Our reference: 88440-Weaver-JulianTerrace-LetterV1

Neath Port Talbot County Borough planning reference: P2020/0303

Site: Site Adjacent to Julian Terrace, Port Talbot SA12 6UE

Development: Construction of A Ground Floor Retail Unit And 2 No. First Floor One Bedroom Apartments with Associated Parking And Amenity Space.

Figure 1: Modelled maximum 1:100 year flood extent with allowance for climate change. Site location shown by red cross (Source: NRW, OS Mapping)

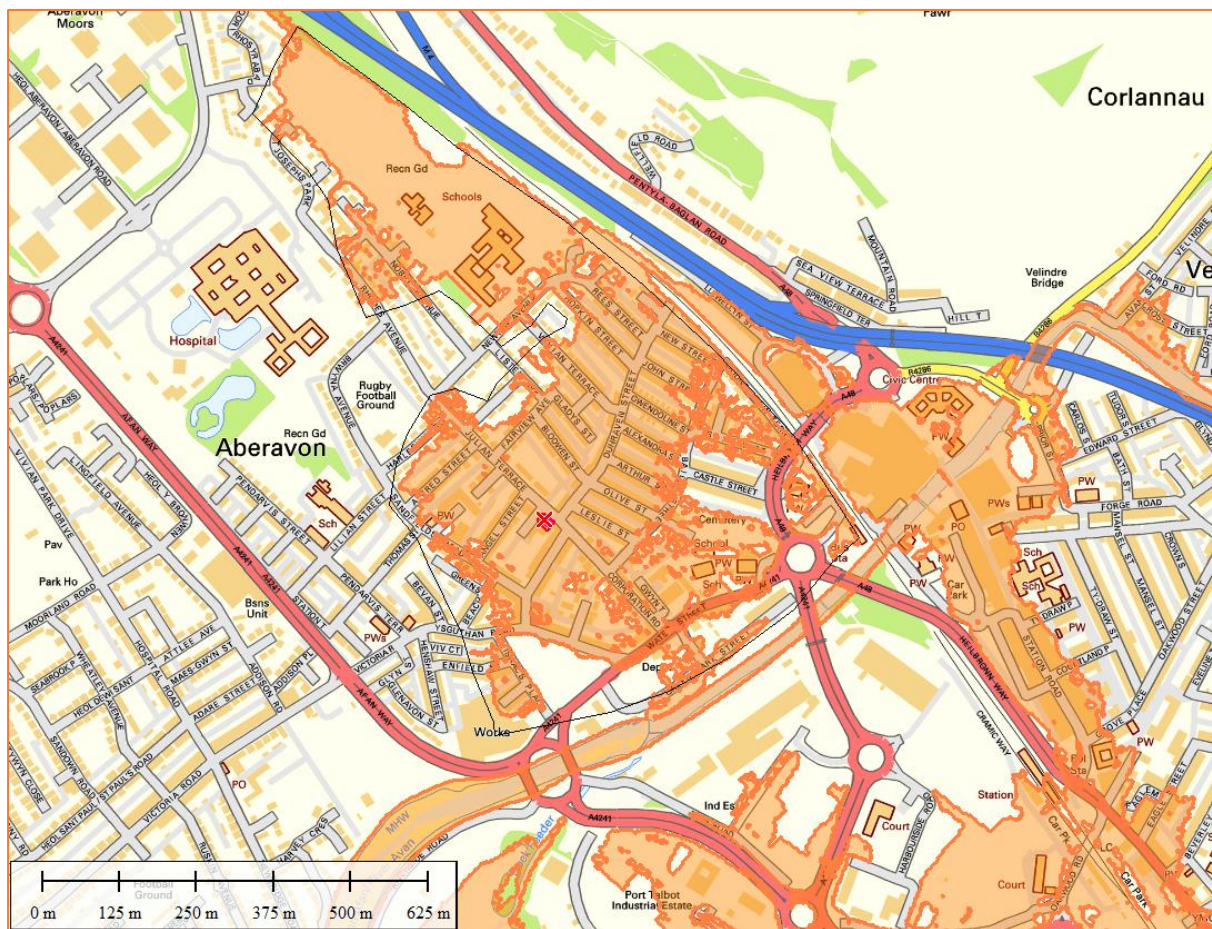
- 1. The effects of the reduction of existing flood storage volume and/or flood conveyance with the effects elsewhere must be quantified (i.e. change in flood levels elsewhere, identify whether additional properties at risk, onset of flooding etc.) and appropriate compensatory storage provided to mitigate any increases and/or other negative impacts. We note that the FCA does not include any assessment of this and should be included in an updated FCA*

Given the extensive fluvial floodplain a simple floodplain storage calculation has been undertaken to assess the impact of the potential 195m² increase in building footprint. It should be noted that the flood cell has been outlined, delineating land shown to be within the modelled maximum 1:100 yr + climate change modelled flood extent.

- The proposed net new building footprint within the 1:100yr (+CC) floodplain is: 195m².
- The on site 1:100yr (+CC) flood level is: 5.65mAOD.
- At 5.65mAOD, the proposed increased building footprint will take up approximately: 117.0m³ of storage volume (average depth of 0.6m).
- The usable flood cell area at the 1:100 year (+CC) flood level is approximately 473500m².
Total usable flood cell area for analysis:

With a potential increase in flood level of 0.247mm (less than a quarter of a mm), the impact of the increase in built footprint on site post development is considered to be negligible. There will therefore be no unacceptable loss in flood storage on site post development.
